ARCHITECT'S SUPPLEMENTAL INSTRUCTIONS

PROJECT:	The Residence at Green Meadow New Senior Development San Angelo, TX	Report No.	One (1)
OWNER:	Overland Property Group Dan Maximuk 234 N. Santa Fe Ave, Suite A Salina, KS 67401	Date	Dec. 18, 2024
CONTRACTOR:	MCP Group 3501 SW Fairlawn Rd. Topeka, KS 66614	Architect's Proj No.	24-3395
		Contract For:	General Construction Mechanical, Electrical

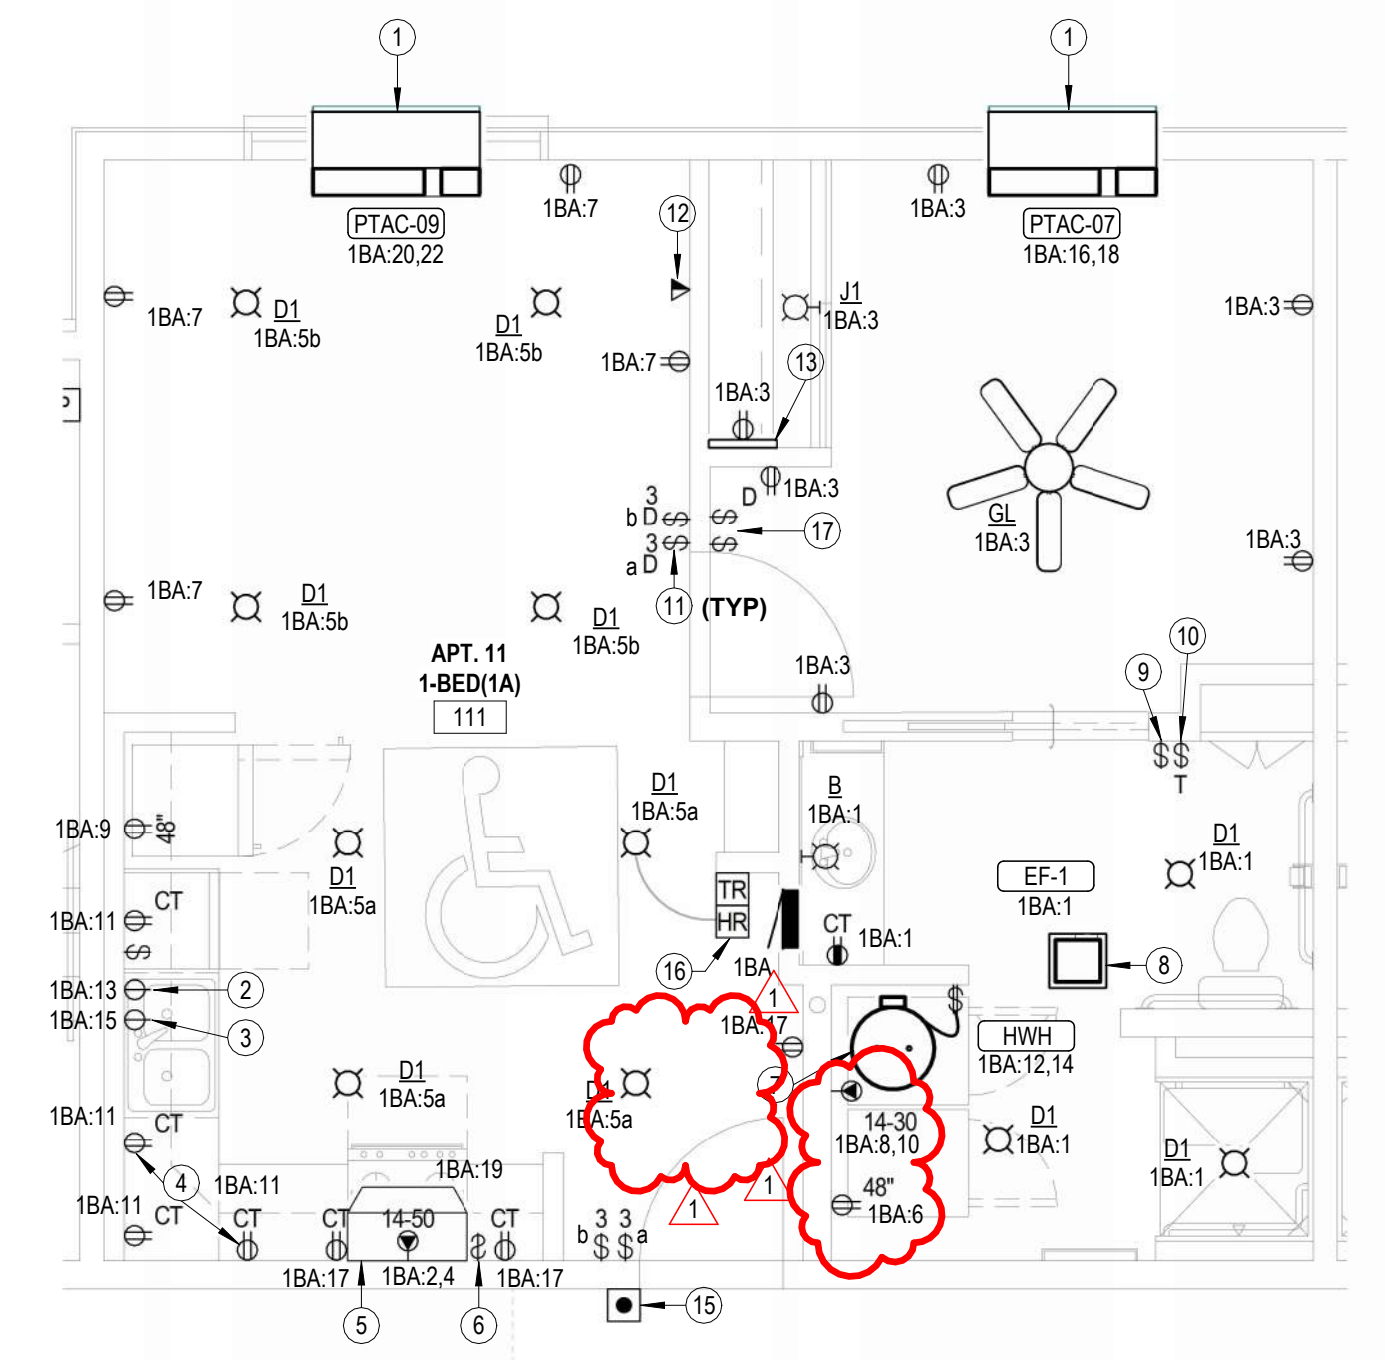
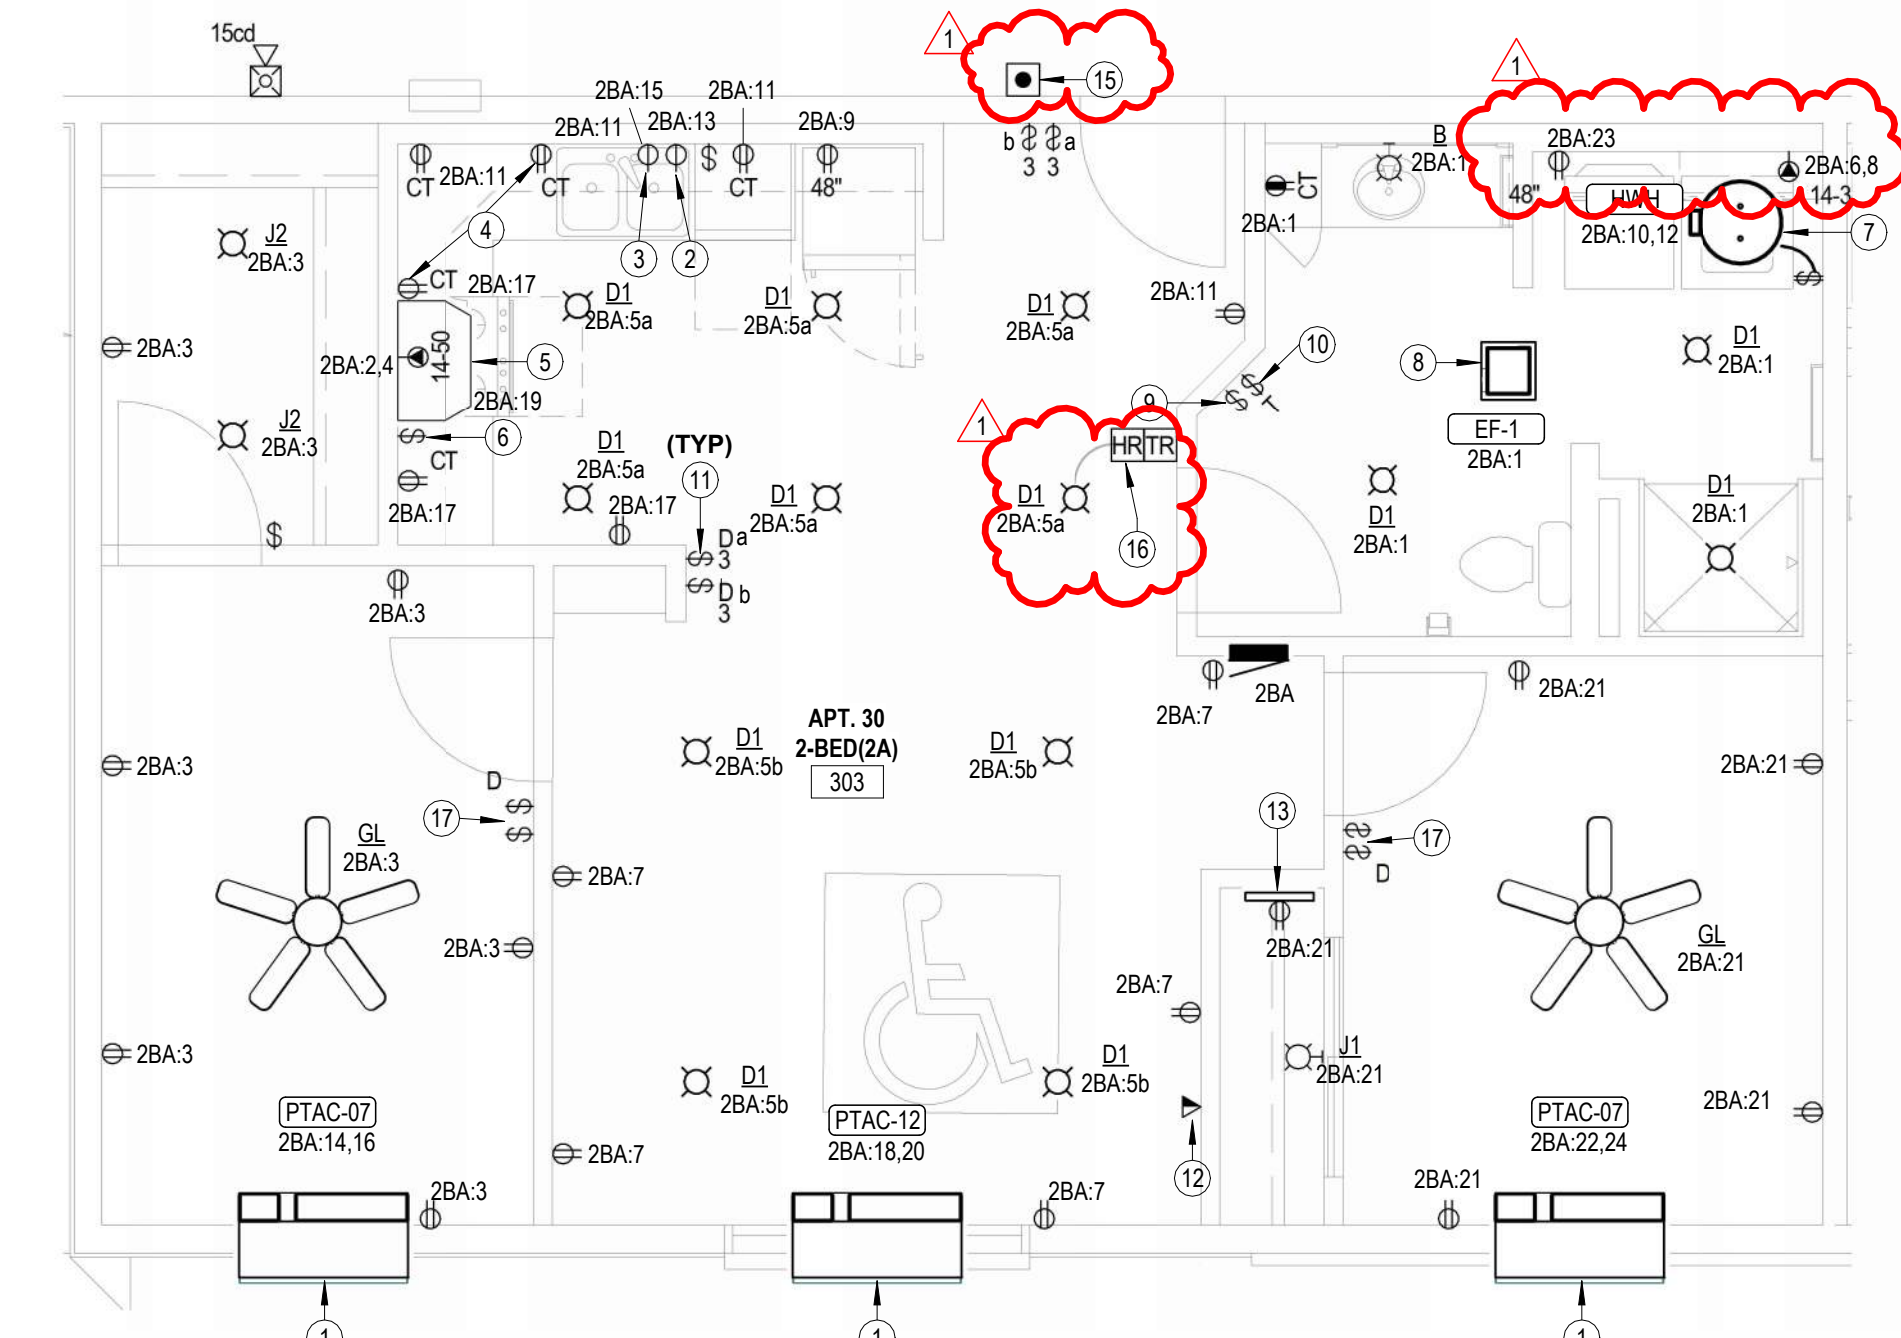
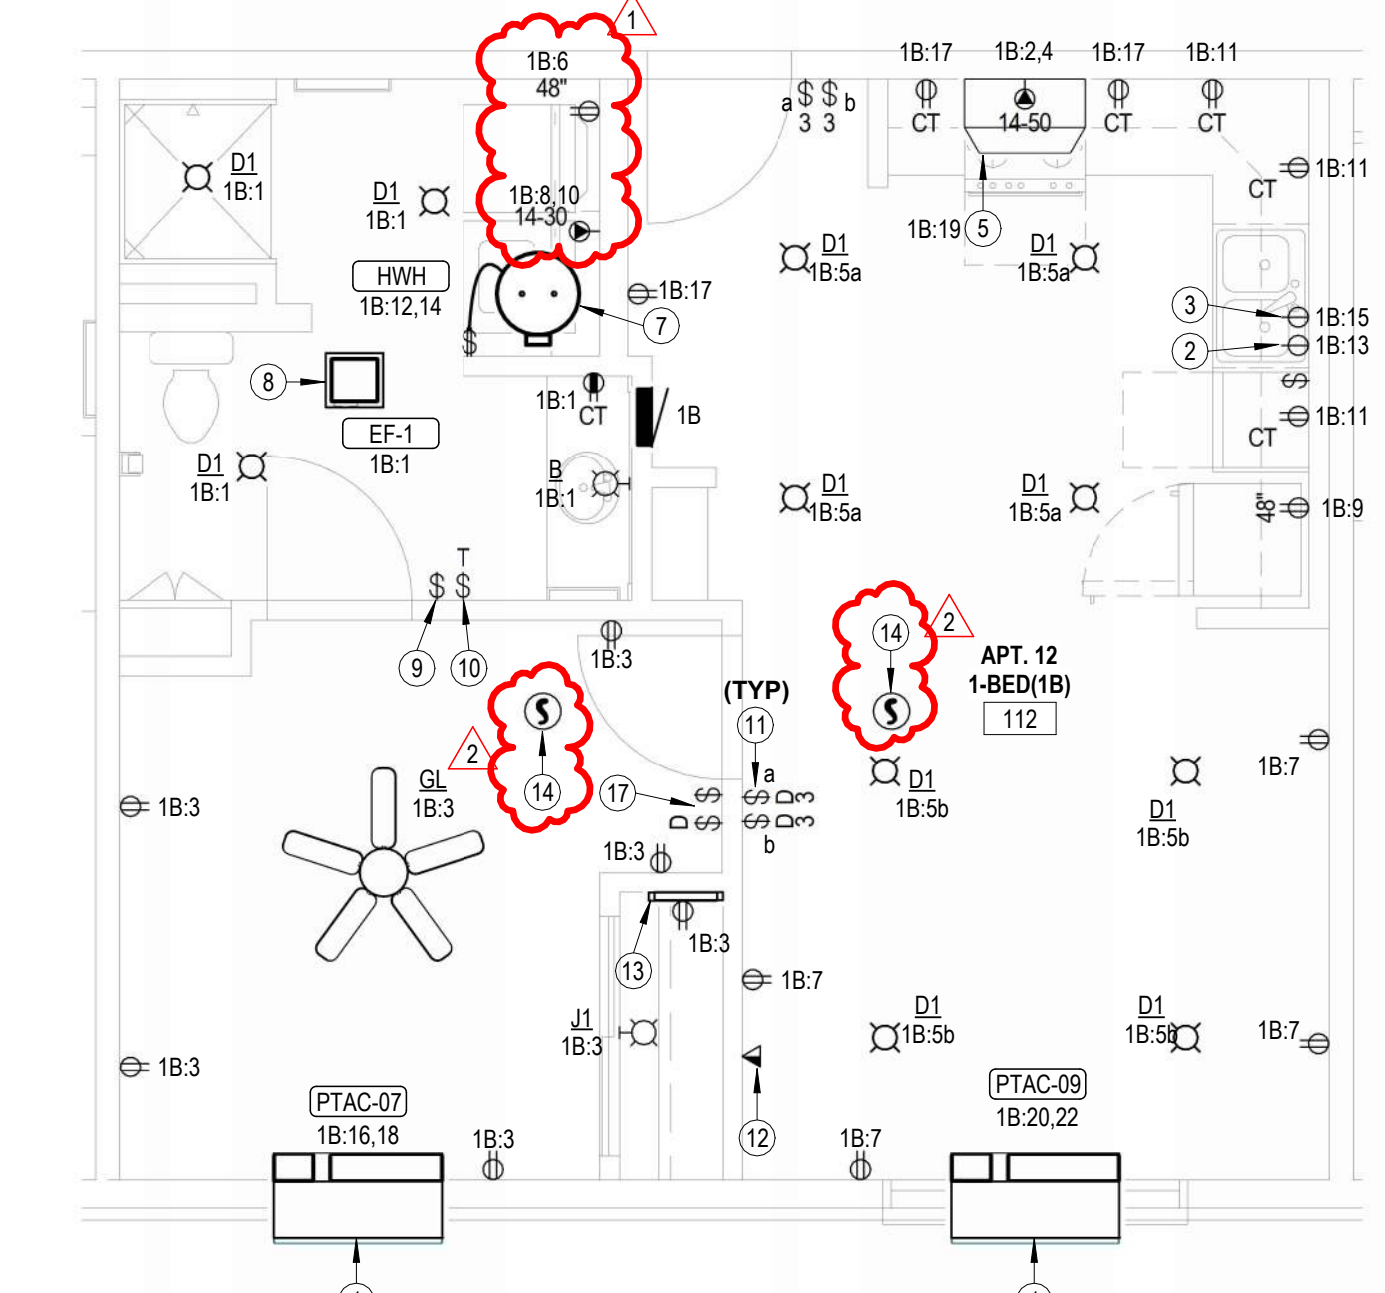
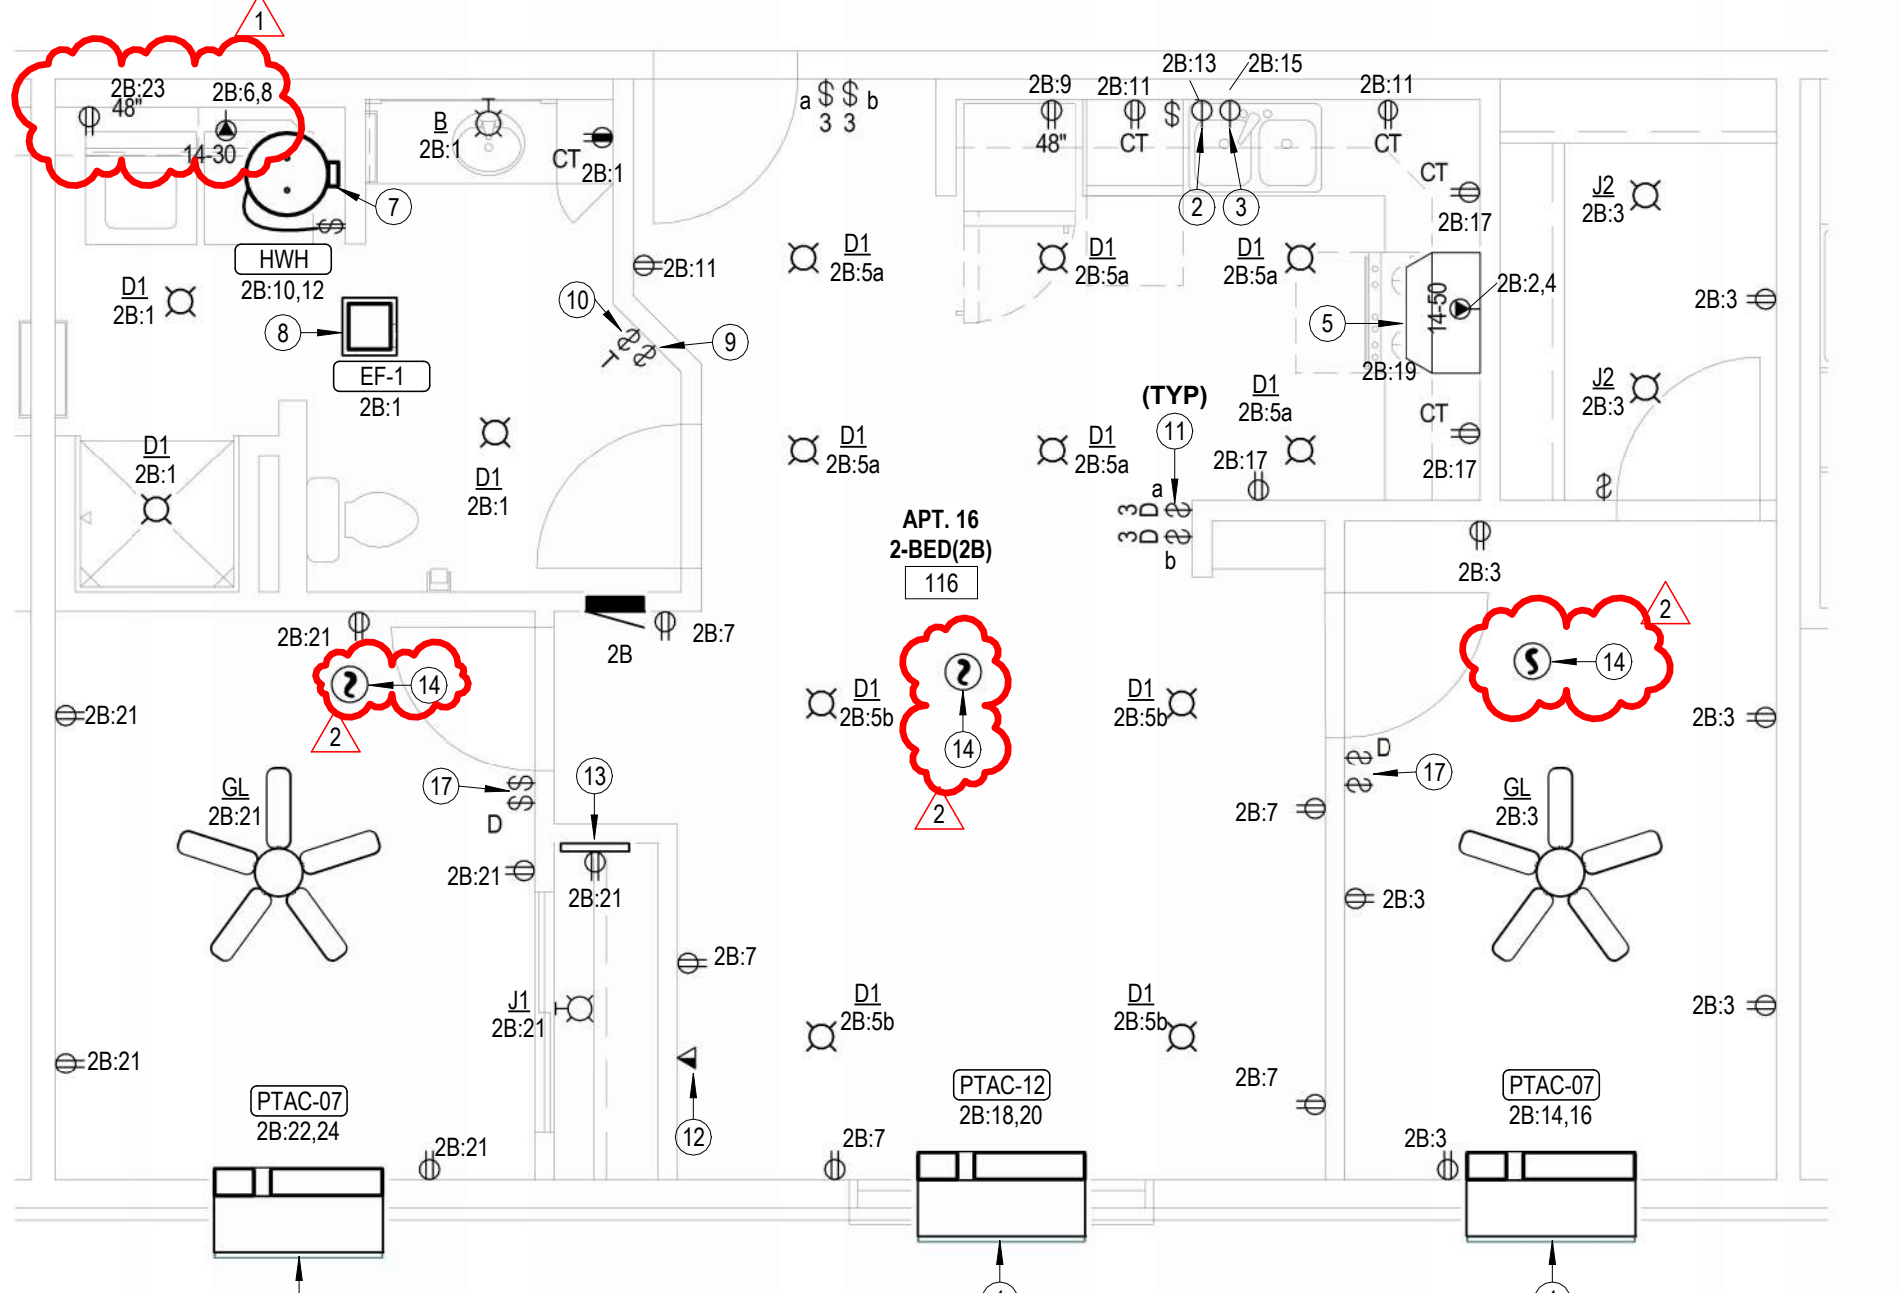
- 15) Sheet E1.2 – Added power on roof for future radon fans.
- 16) Sheet E4.1 – Added smoke detectors in standard bedrooms (accessible smoke detectors are shown on E1.3 and E1.4)
